## DEVELOPMENT APPLICATION ASSESSMENT REPORT

<b>Application Number:</b>	DA2021/0006
<b>Responsible Officer:</b>	Anne-Marie Young
<b>Land to be developed (Address):</b>	Lot 14 DP 12012, 10 Jamieson Parade COLLAROY NSW 2097
<b>Proposed Development:</b>	Demolition works and construction of a dwelling house including swimming pool and spa
<b>Zoning:</b>	Warringah LEP2011 - Land zoned R2 Low Density Residential
<b>Development Permissible:</b>	Yes
<b>Existing Use Rights:</b>	No
<b>Consent Authority:</b>	Northern Beaches Council
<b>Delegation Level:</b>	NBLPP
<b>Land and Environment Court Action:</b>	No
<b>Owner:</b>	Andrew Peter Lutze Shae Eliza Lutze
<b>Applicant:</b>	Andrew Peter Lutze

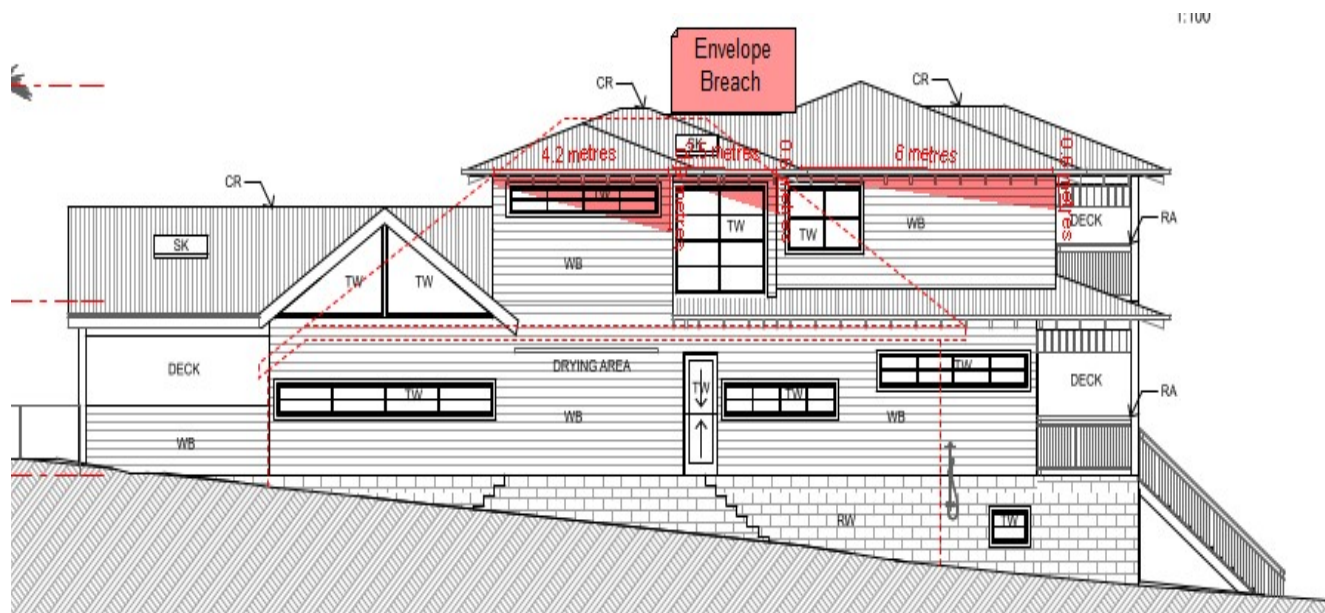
The minor breach in the wall height will not in itself add to unreasonable impacts on view sharing along the existing view corridor.

The roof pitch provides variation in its design.

*Northern elevation*

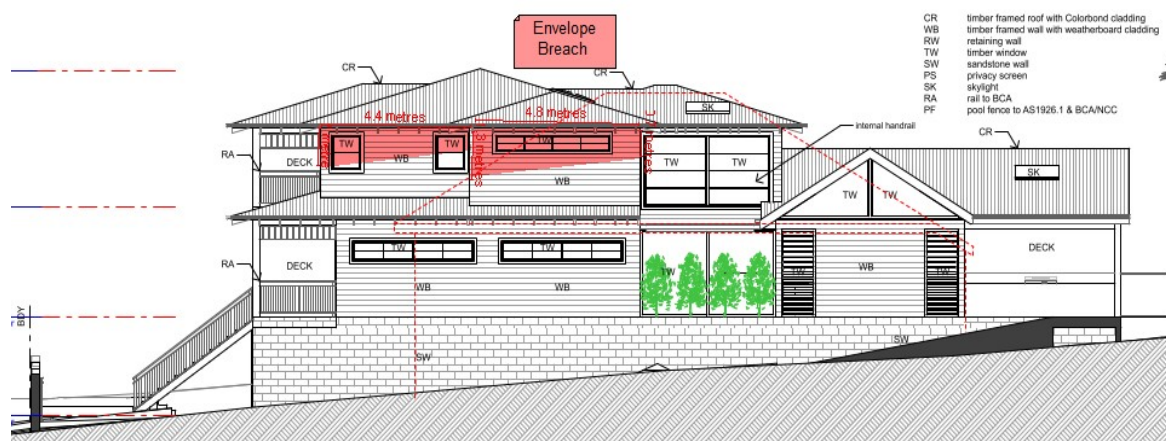
Area 3 - 0.9m - 0m in height x 4.2m in length relates to bedroom 3

There are two areas of non-compliances, as detailed below:
